Well Name: JAMES RANCH UNIT	Well Location: T23S / R30E / SEC 1 / SESE / 32.3300855 / -103.8280457	County or Parish/State: EDDY / NM
Well Number: 82	Type of Well: OIL WELL	Allottee or Tribe Name:
Lease Number: NMNM02884B	Unit or CA Name: CONSL DWRM FMN PA ABC	Unit or CA Number: NMNM70965K
US Well Number: 3001531208	Operator: XTO PERMIAN OPERATING LLC

Type of Submission: Notice of Intent Type of Action: Plug and Abandonment

PLUG AND ABANDON WELLBORE
JAMES RANCH UNIT 082
EDDY COUNTY, NEW MEXICO
Class II

Action 384683

JRU 82 - Proposed WBD

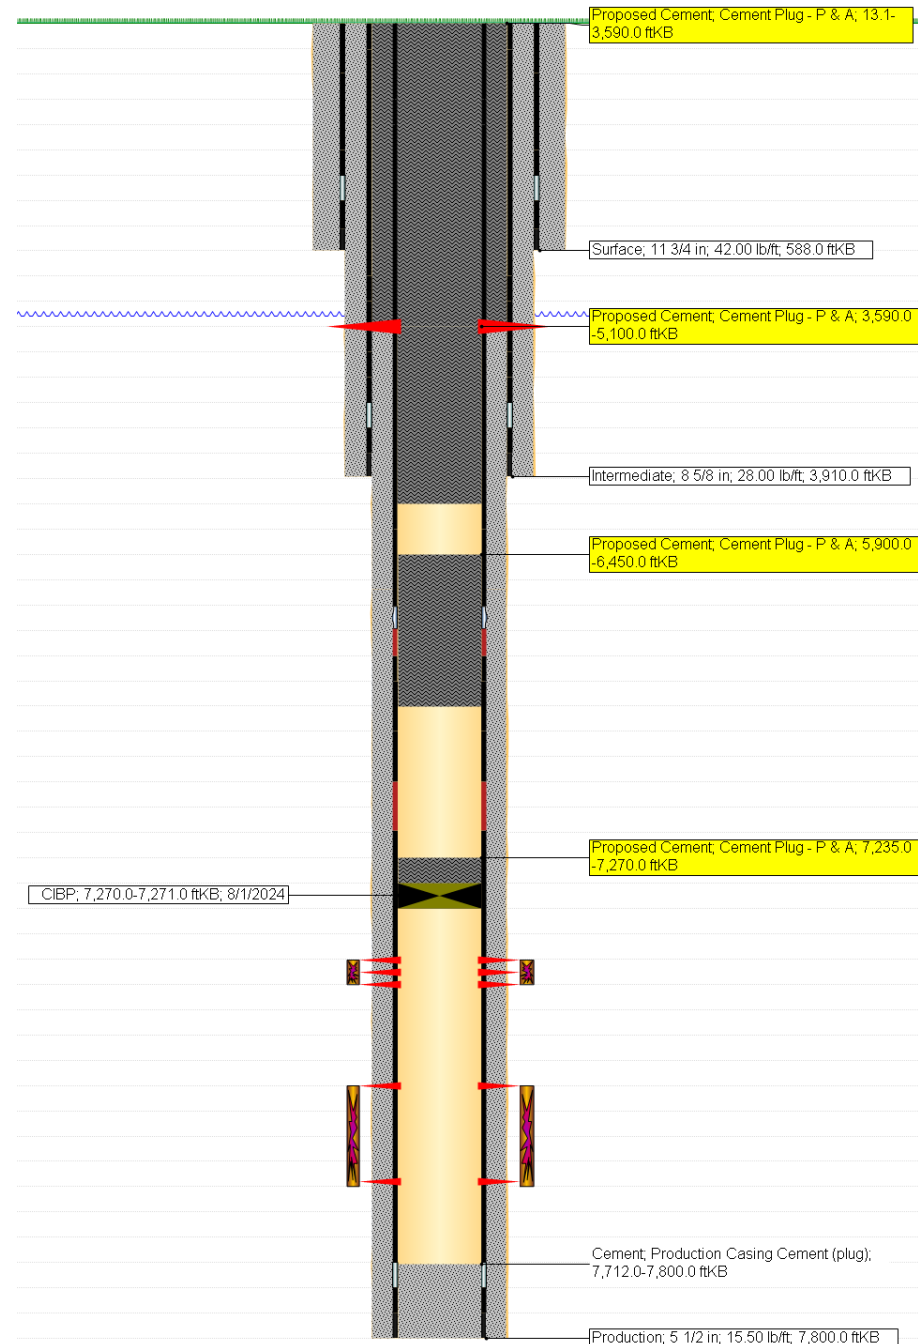
Perf and circulate from TOC to surface.

Spot 155 SKS Class C: 5,100' to TOC. WOC and Tag

Spot 70 SKS **Class H**: 6,450' to 5,900'. WOC and Tag

Dump bail 35' **Class H** atop CIBP: 7,270' to 7,235'. PT CIBP to 500 PSIG for 30 min. WOC and Tag.

JRU 82 - Proposed WBD

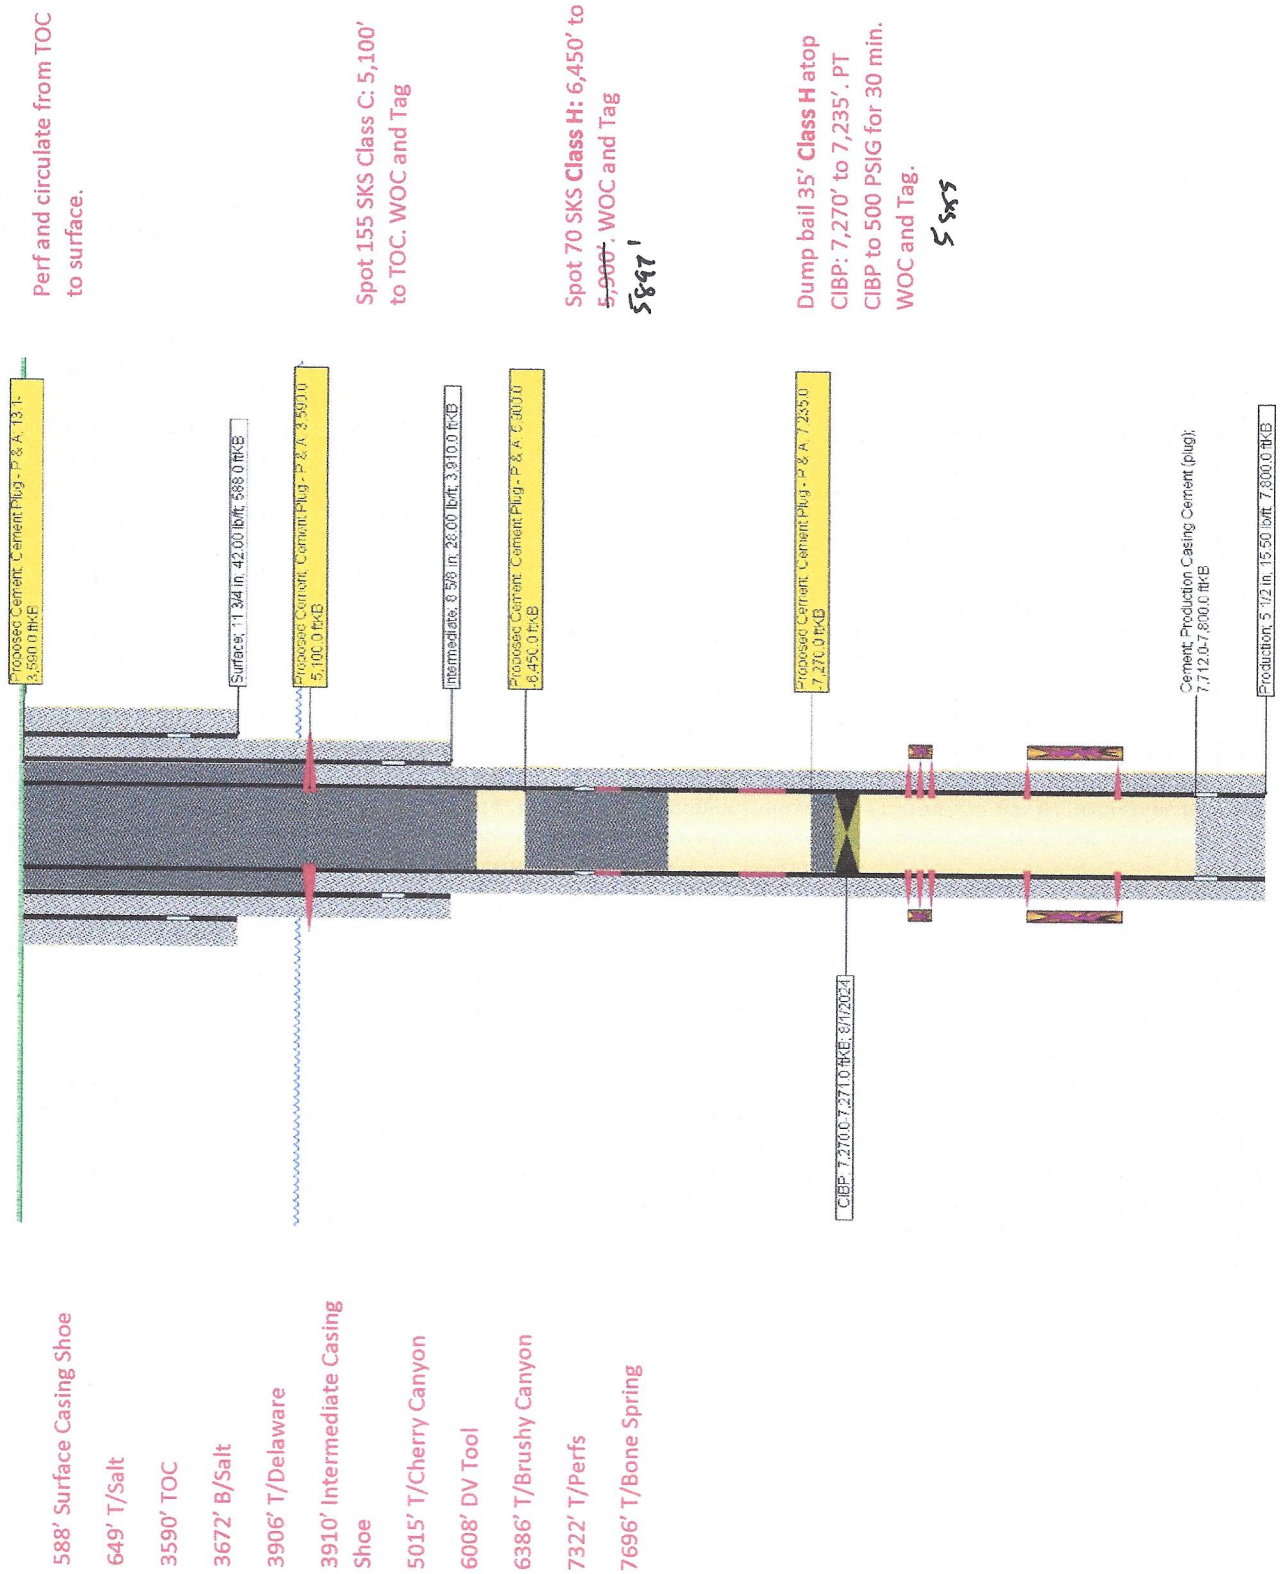
Plug Type	Top	Bottom	Length	Tag	Sacks	Cement Class	Notes
Surface Plug	0.00	100.00	100.00	Tag/Verify			
Fresh Water @ 350	296.50	400.00	103.50	If solid

11.75 inch- Shoe Plug	532.12	638.00	105.88	Tag/Verify			
Top of Salt @ 649	592.51	699.00	106.49	Tag/Verify			
Base of Salt @ 3490	3405.10	3540.00	134.90	Tag/Verify	869.00	C	Perf and squeeze from 3590' to surface. Verify at surface. (In 364 sxs/Out 505 sxs)

8.625 inch- Shoe Plug	3820.90	3960.00	139.10	Tag/Verify			
Delaware @ 3930	3840.70	3980.00	139.30	If solid base no need to Tag (CIBP present and/or Mechanical Integrity Test), If Perf & Sqz then Tag, Leak Test all CIBP if no Open Perforations	155.00	C	Spot cement from 5100' to 3590'. WOC and Tag.
DV tool plug	5897.92	6058.00	160.08	Tag/Verify	25.00	C	Spot cement from 6058' to 5897'. WOC and Tag.
CIBP Plug	7235.00	7270.00	35.00	If solid base no need to Tag (CIBP present and/or Mechanical Integrity Test), If Perf & Sqz then Tag, Leak Test all CIBP if no Open Perforations	5.00	H	Set CIBP at 7270'. Dump bail 35' on top. Leak test CIBP.
Perforations Plug (If No CIBP)	7272.00	7662.00	390.00	Tag/Verify			
Bonesprings @ 7674	7547.26	7724.00	176.74	If solid

5.5 inch- Shoe Plug	7672.00	7850.00	178.00	Tag/Verify

Created By	Condition	Condition Date
gcordero	Run CBL from 7270' to surface.....CBL must be submitted to OCD via OCD Permitting prior to submitting C-103P	10/1/2024
